ADDENDUM NO. 1

To: All Planholders
From: Antonio L. Reyna, PE
Subject: Harlingen Economic Development Corporation
The Park at Roosevelt – EDA Grant Project
Date: August 30, 2024

- I. Replace Plan Sheets 3, 9 and 10 with attached Revised Plan Sheets 3, 9 and 10, Addendum No. 1, dated 8/30/2024.

SCALE: AS SHOWN
DRAWN BY: S.M.
FILE: 544-021
DATE: 08/20/2024

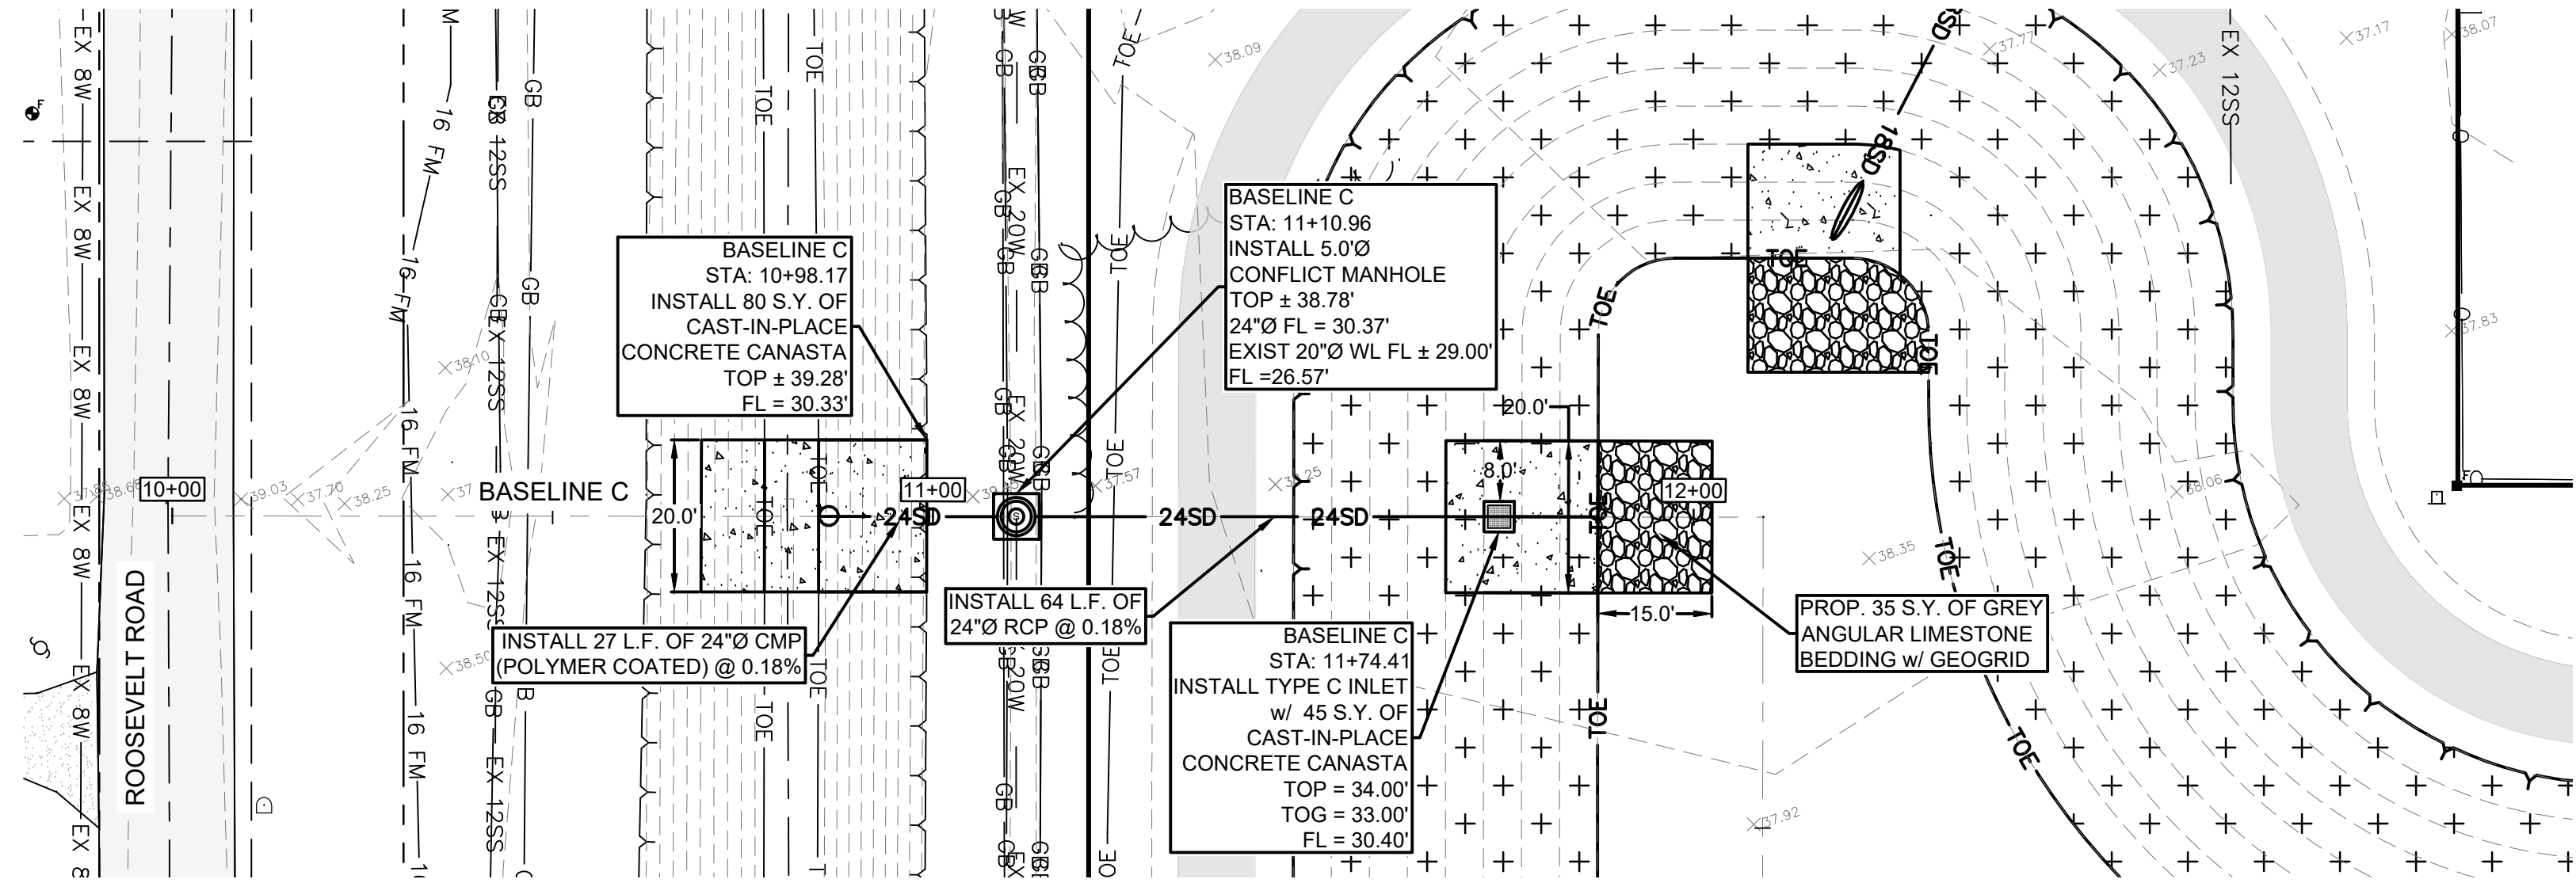
REVISIONS:
08/30/2024
ADDENDUM NO. 1
ADD SPOILS AREA

HARLNGEN ECONOMIC DEVELOPMENT CORPORATION
THE PARK AT ROOSEVELT - EDA GRANT PROJECT
CONSTRUCTION PLANS
STORM SEWER PLAN AND PROFILE
BASELINE C - STA: 10+00 - 13+00

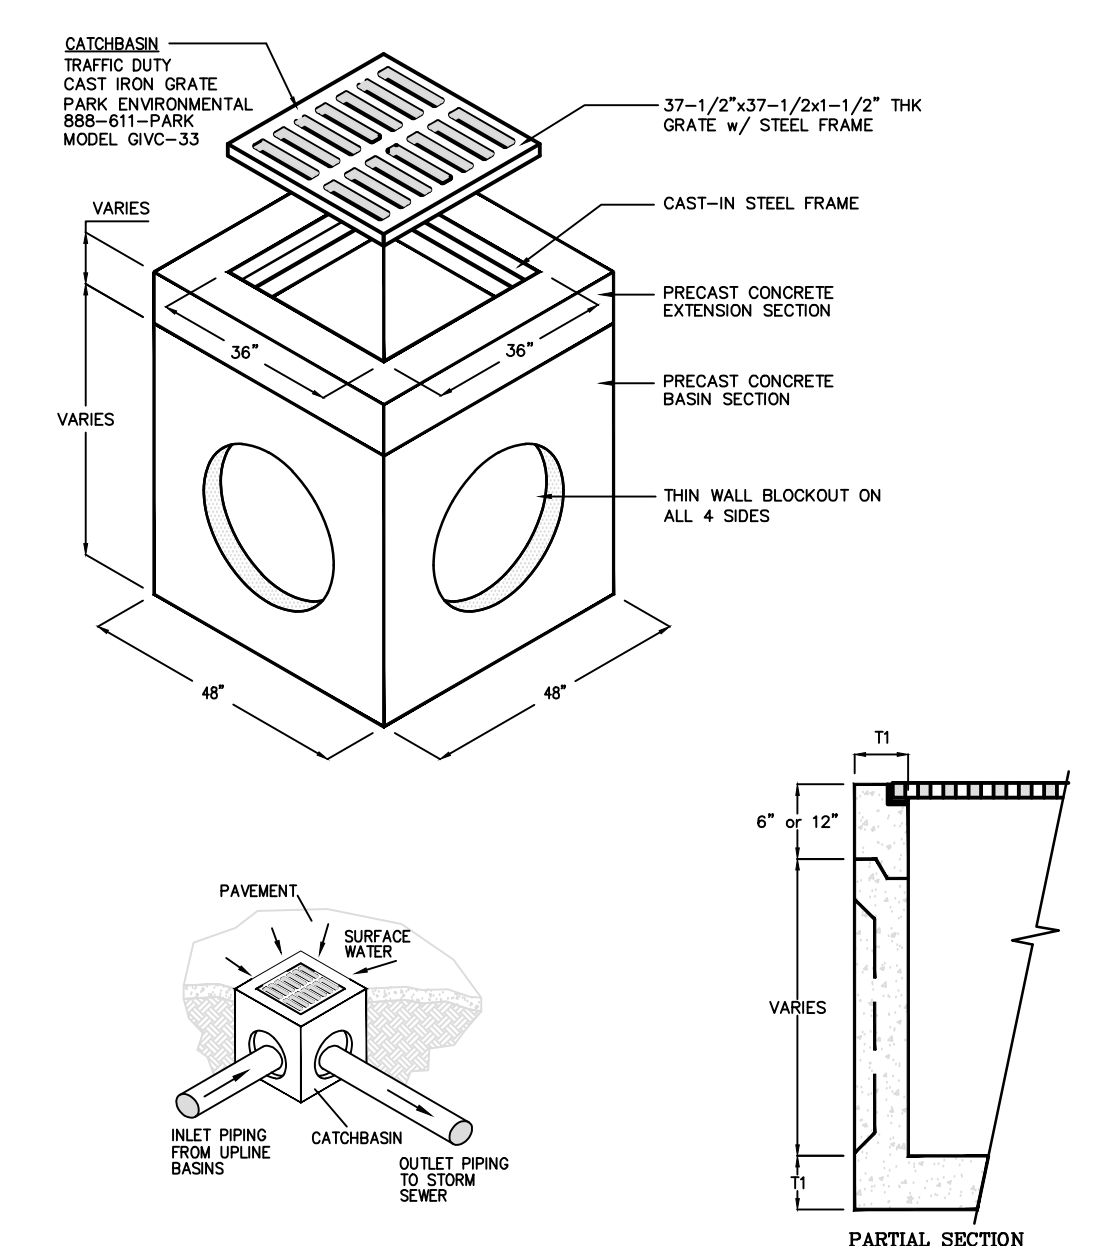
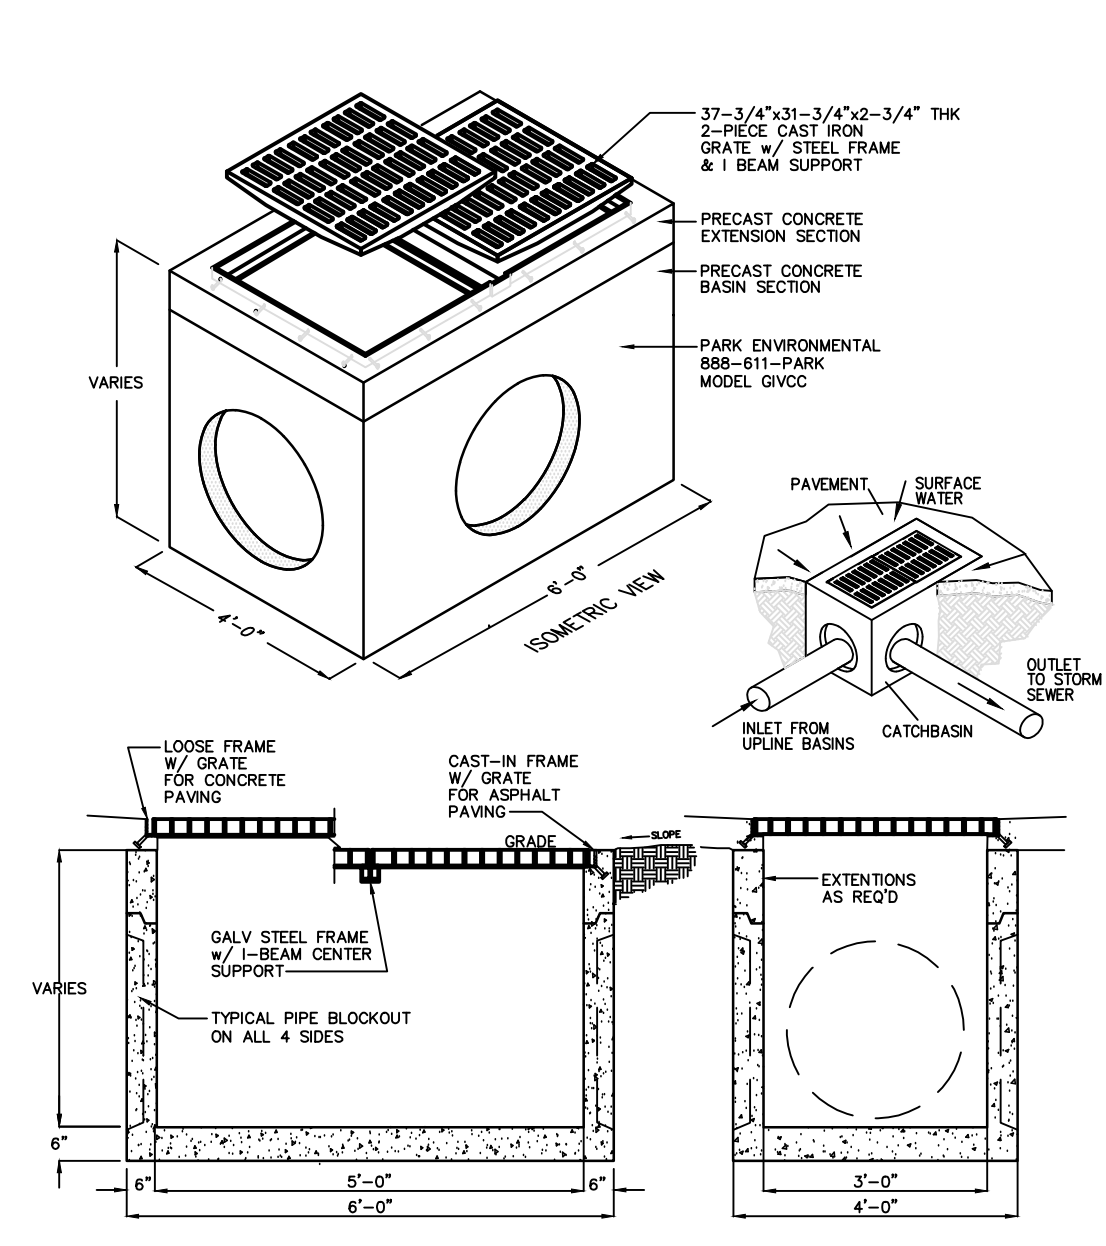
REVISIONS:
08/30/2024
ADDENDUM NO. 1
ADD CASING THICKNESS

STANDARD PIPE BEDDING

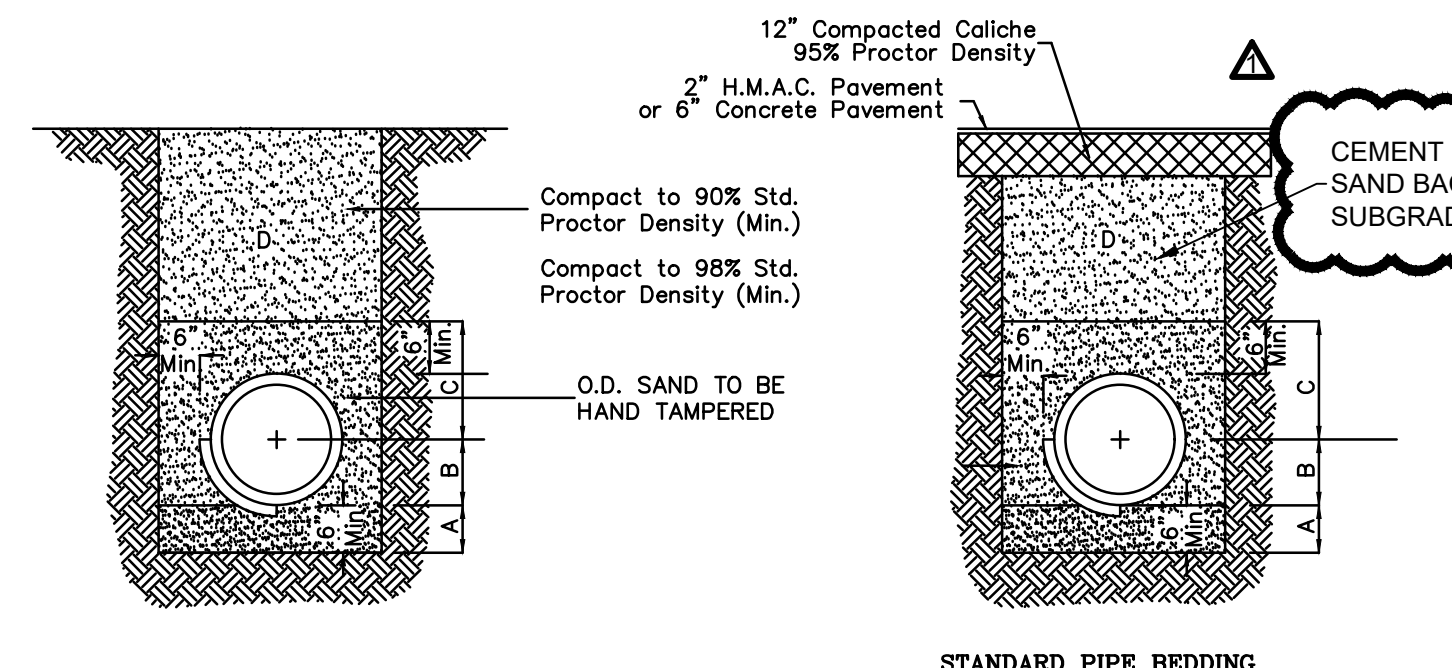
REVISIONS:
08/30/2024
ADDENDUM NO. 1
ADD STABILIZED SAND BACKFILL NOTE
